305 S. CONGRESS PUD
Existing Site Survey

COMMENT REVIEW REPORT

This report includes all comments received to date concerning your planned unit development. The planned unit development will be approved when all requirements identified in this report have been addressed. However, until this happens, your planned unit development is considered disapproved.

Setbacks and Land Use Map

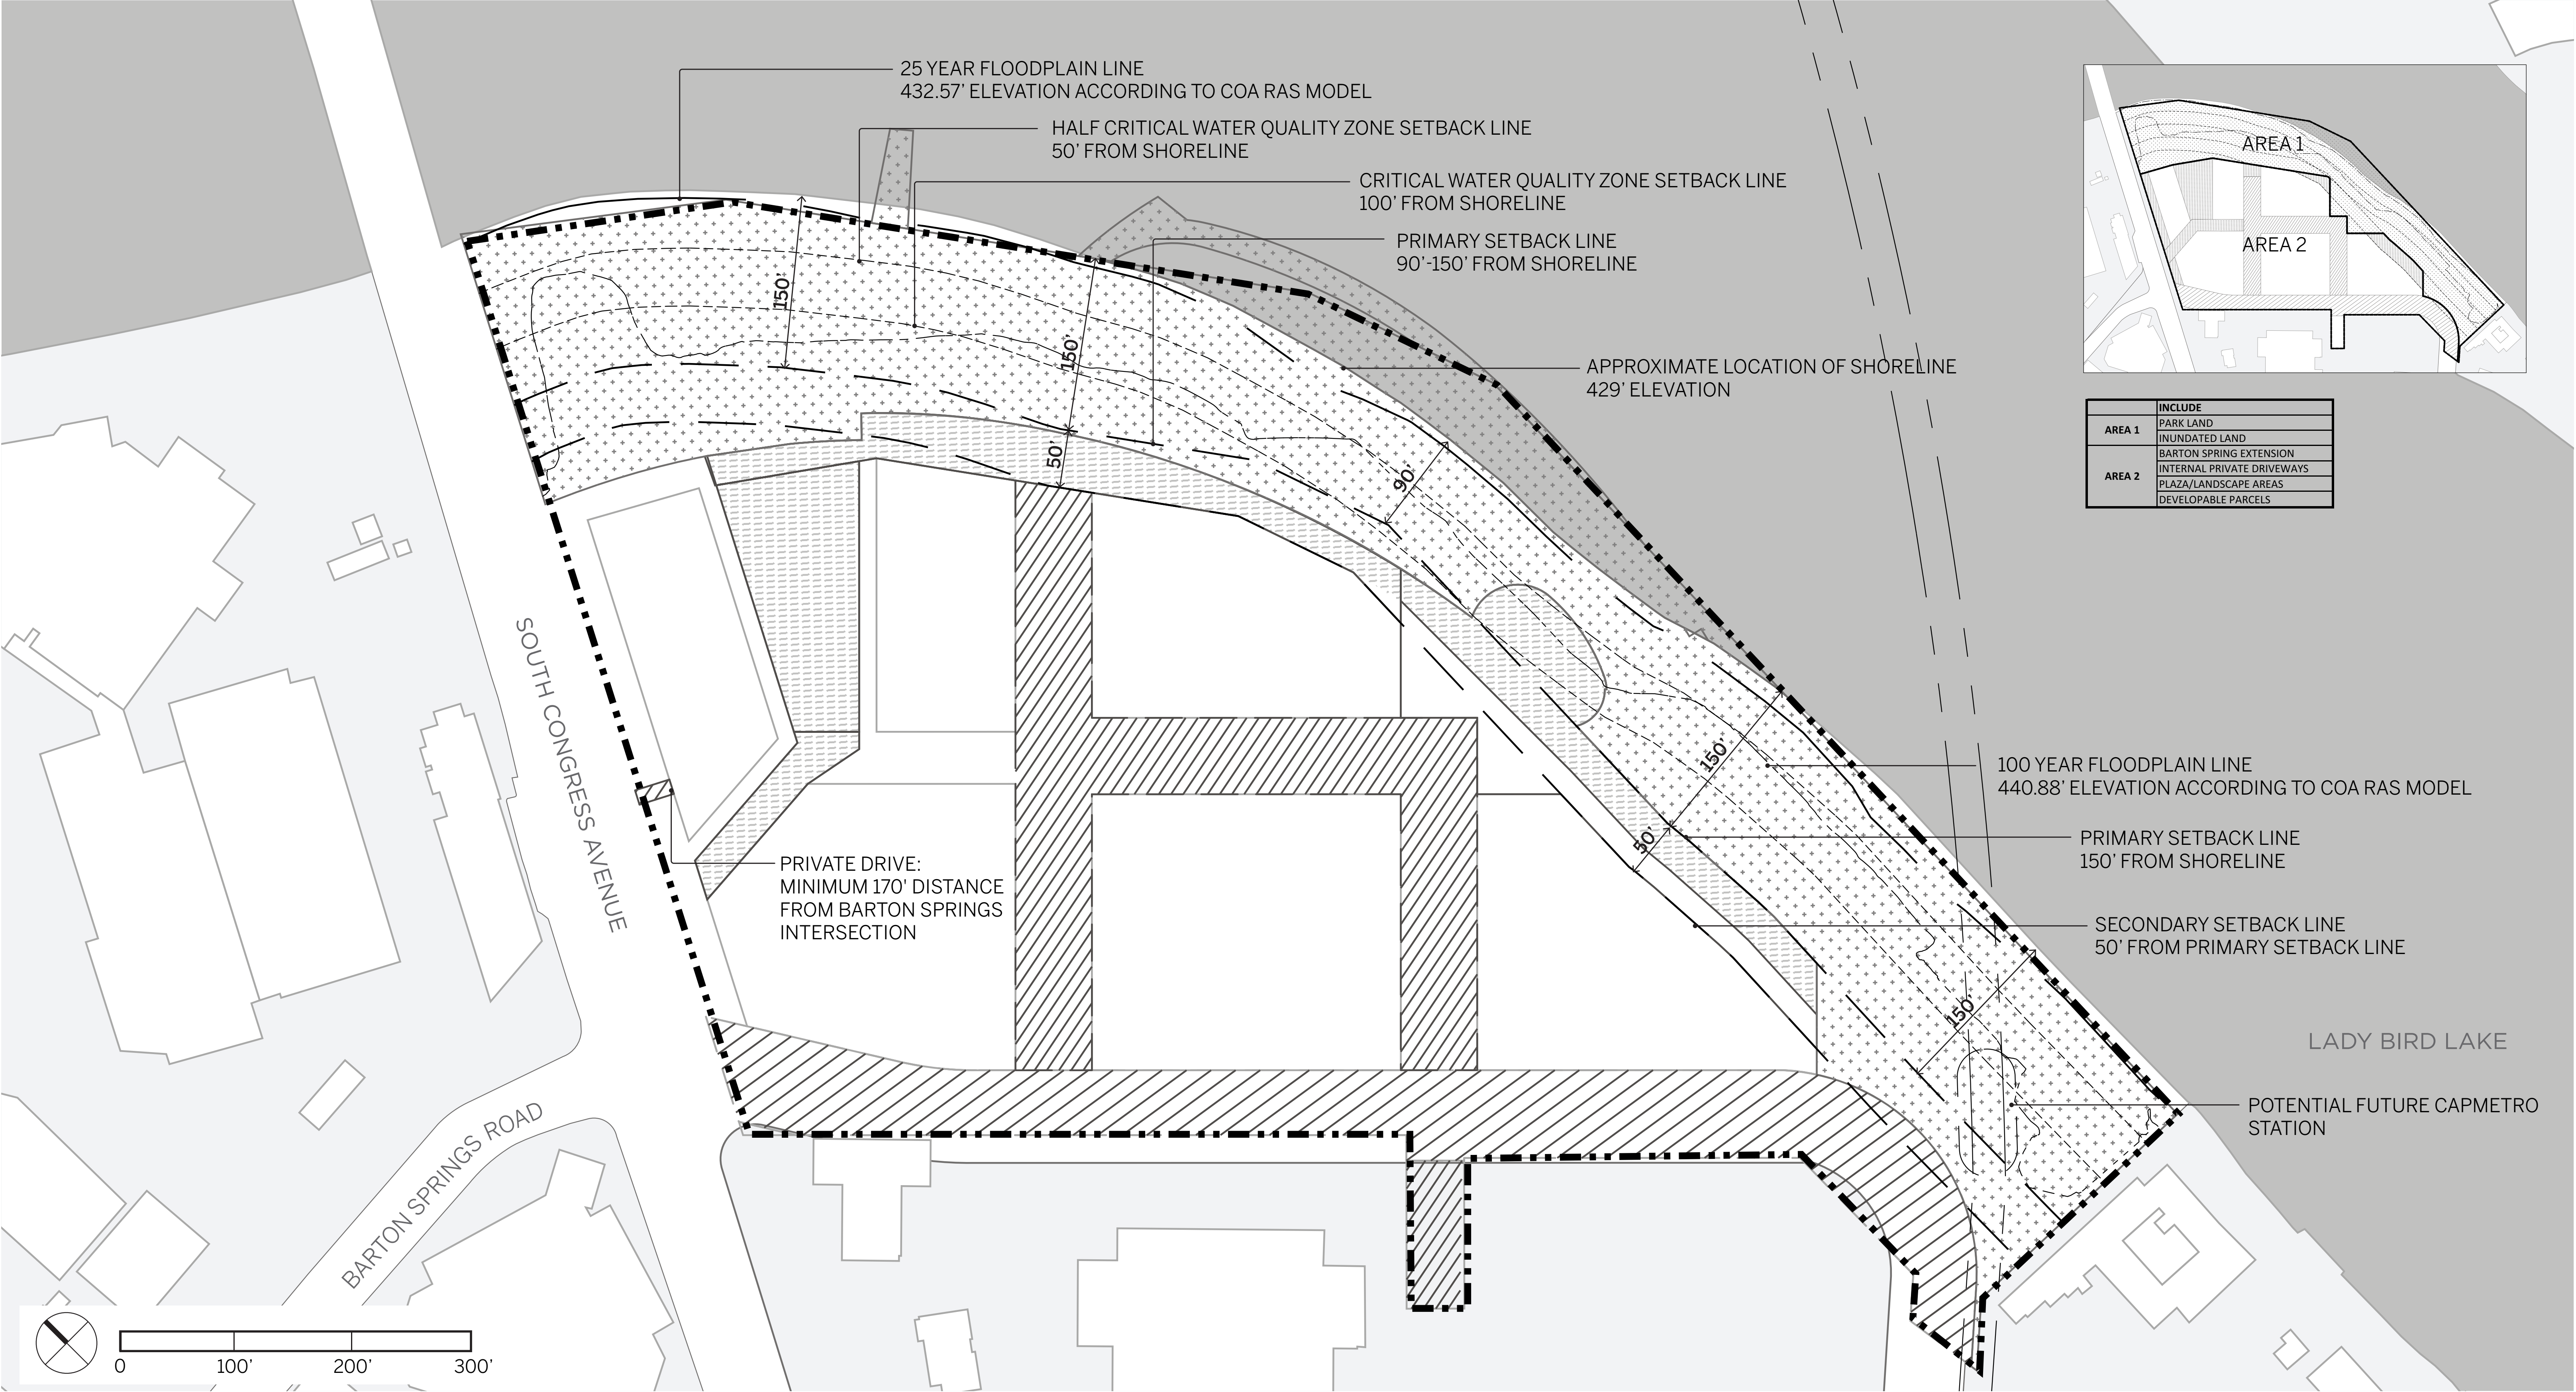
Update 1: Comment pending. Clarification or further division of Pedestrian Oriented Uses is required for Areas 1 and 2. From the *Setbacks and Land Use Map* (Sheet 5) Area 1 is indicated to be the Parkland. It is also mostly encumbered by the Waterfront Overlay Primary and Secondary Setbacks. Staff will not support this extensive of a list for permitted uses within this area. Please provide two separate lists for Pedestrian Oriented Uses for Area 1 and Area 2.

Conceptual Open Space Map

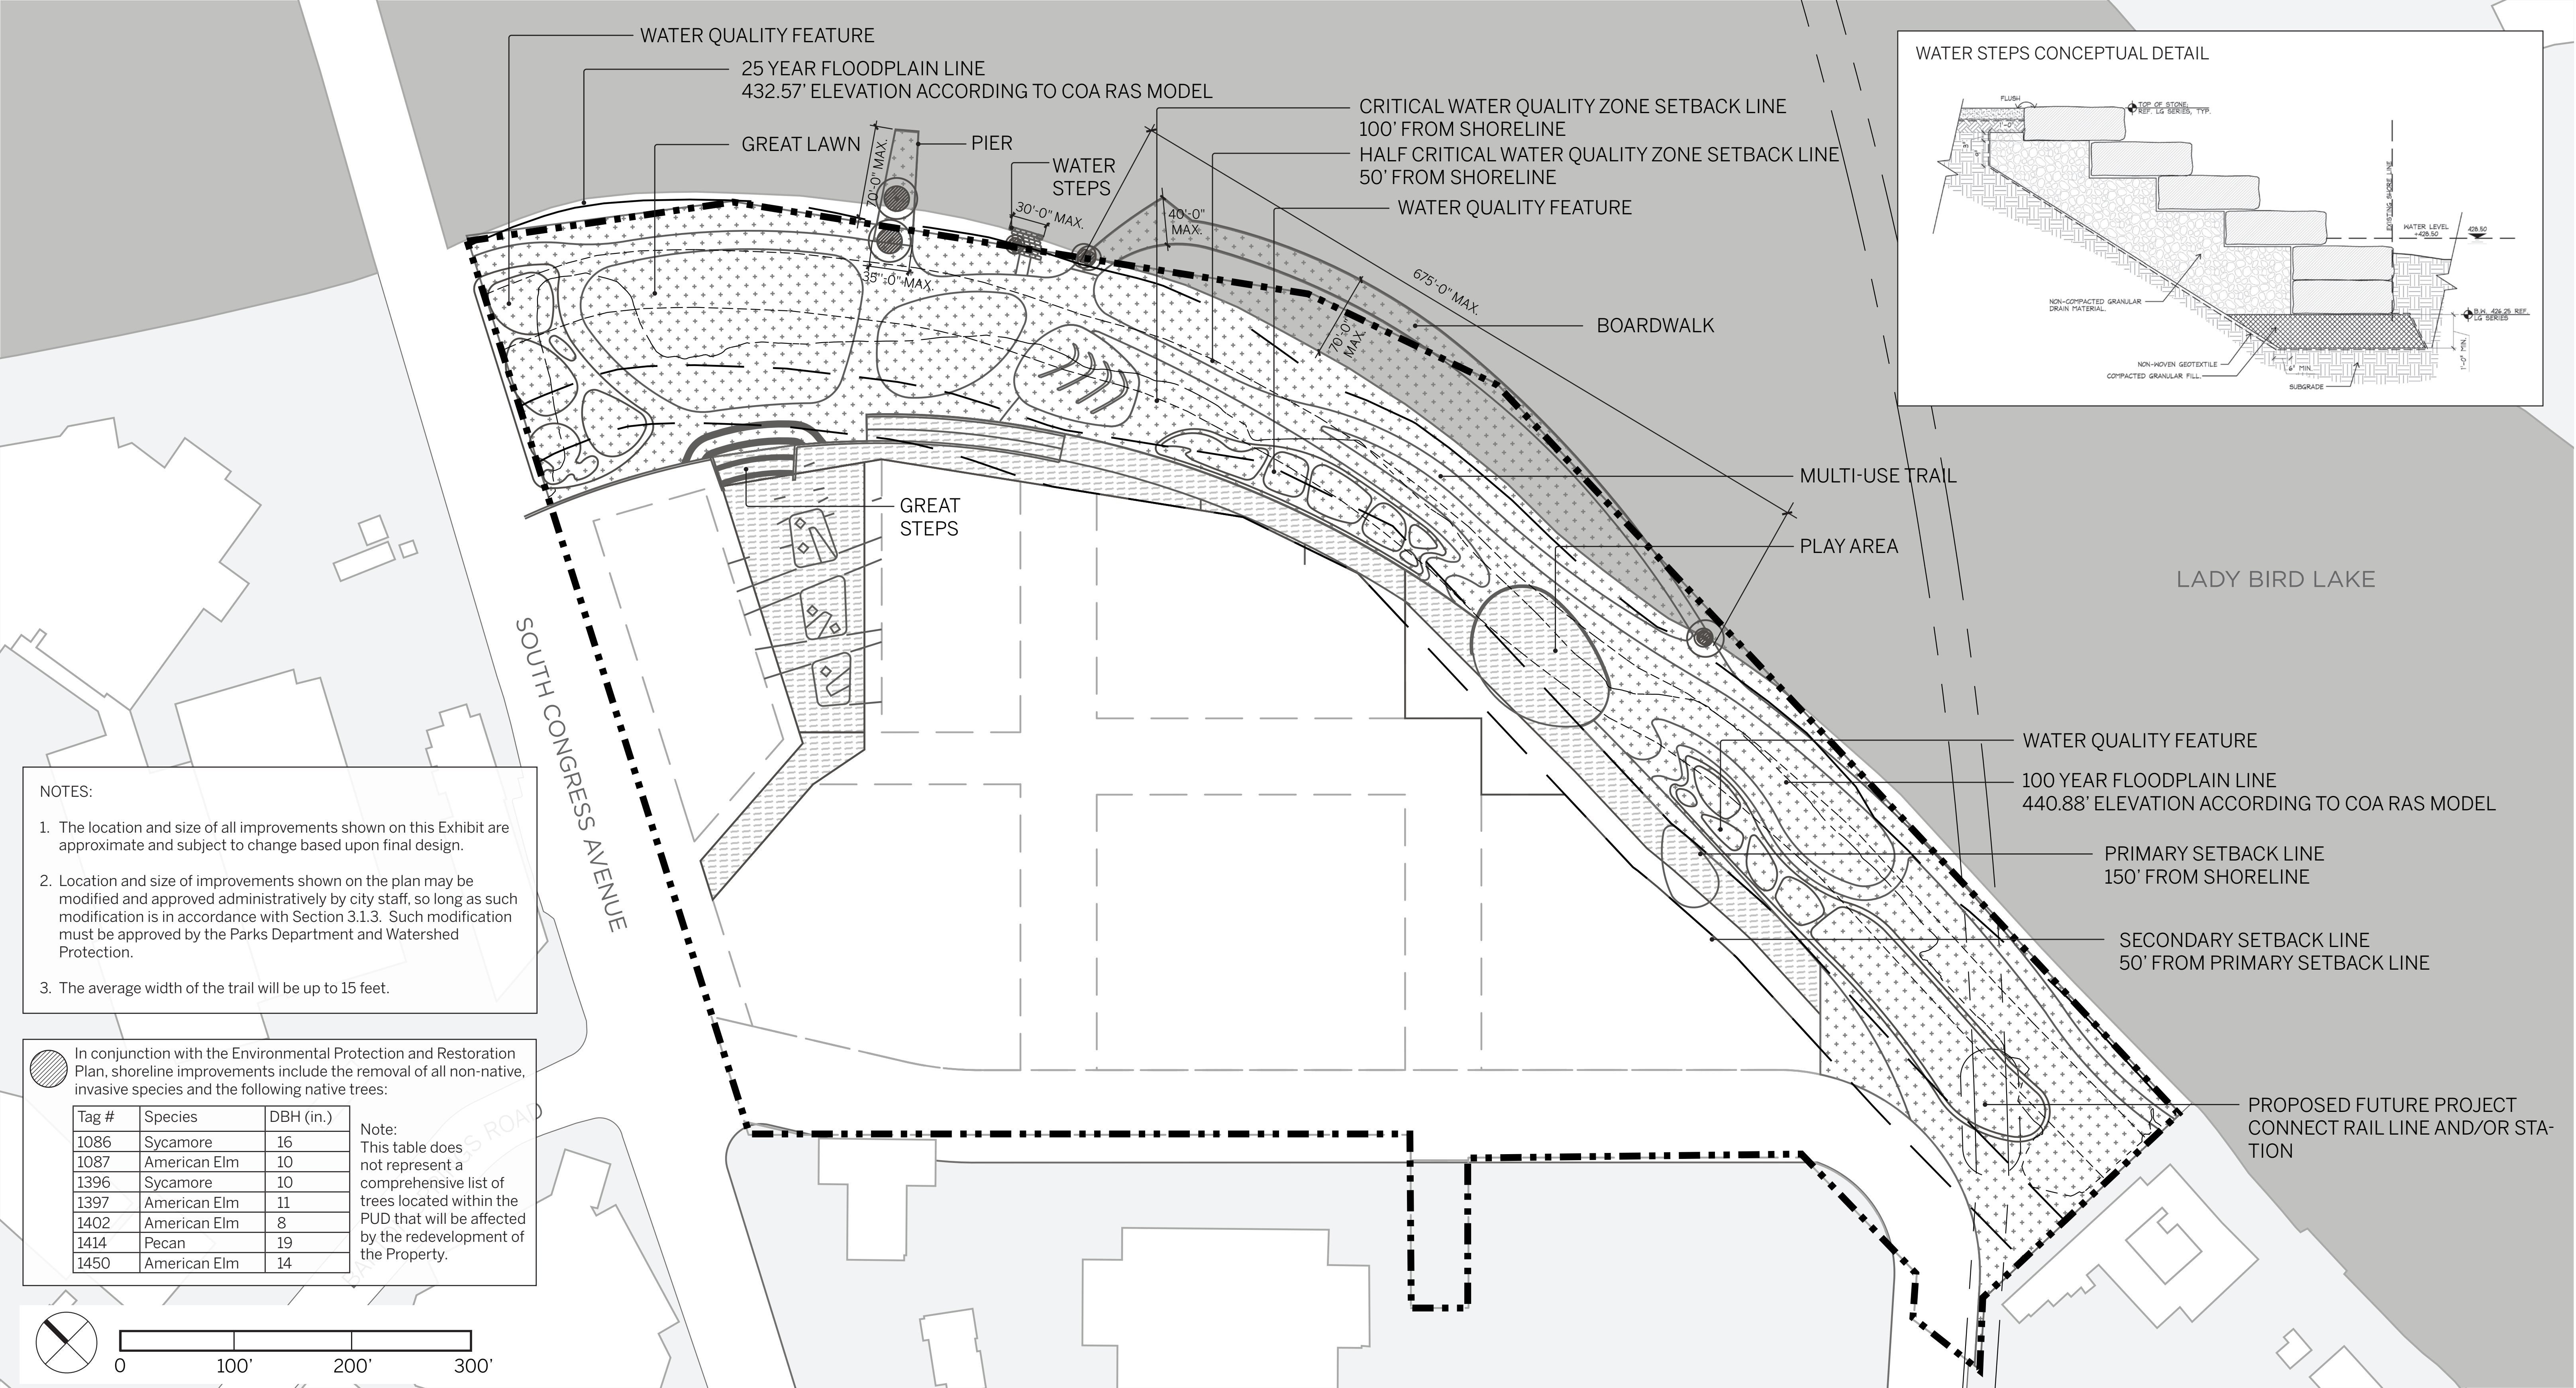
Update 1: Comment pending. Open Space exhibit provided does not match the exhibit or intent of the South Central Waterfront overlay plan. Add a note to the Open Space plan that states: "Improvements shown on the plan are conceptual and will be finalized at time of site plan."

Update 1: Thank you for Open Space Map (Sheet 6). Identify location of pavilions, and any other planned elements not shown on this plan. Since the PUD will unlikely be able to meet the acreage requirements of 10.4 acres per 1,000 residents (see PR4), superiority will need to be made up in design and construction of a superior park system (and the remainder to be made up by fees in lieu of land at time of site plan). See PR 3 regarding park development superiority. Park development shall be consistent with the South Central Waterfront Vision Plan.

Update 1: Please confirm that the Pontoon Landing is the same as “Pier” on Sheet 6.

Figure 1: SCWP envisioned land-sharing for the Barton Springs East Extension

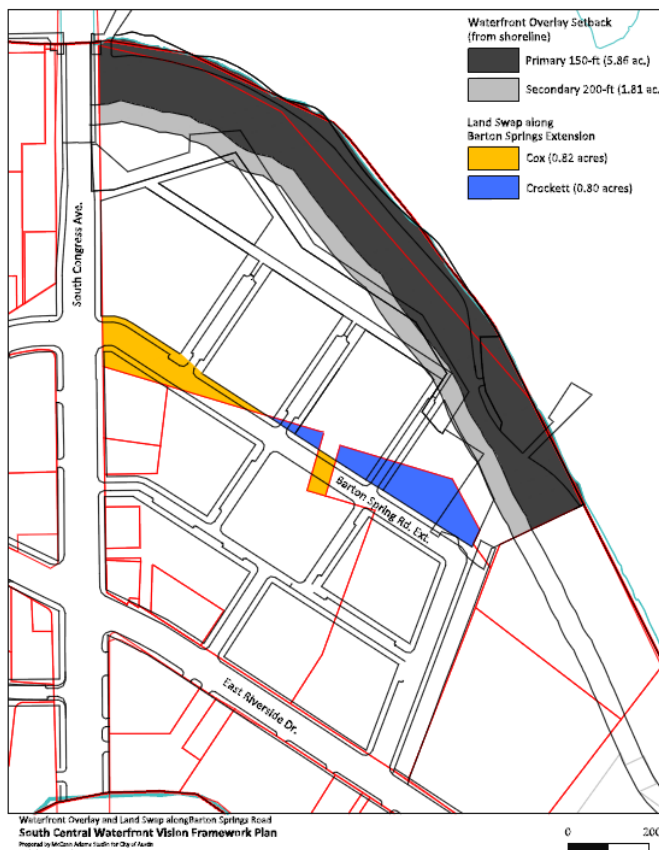
- The SCWP envisioned that the Barton Springs East Extension would place the majority land contribution burden on the Crockett property. According to the SCWP, the 305 S Congress site would contribute 0.82 acres (as shown in Figure 1 in Yellow) towards this street while gaining a roughly equivalent 0.8 acres from the Crockett property (next page, as shown in Figure 1 in Blue) towards the development of the 305 S Congress site., The PUD proposal includes a land contribution (1.61 acres) that would have been otherwise available for development.
 - The SCWP would deem this contribution as a community benefit that should count towards the Applicant's in-kind, on-site community benefit contribution.
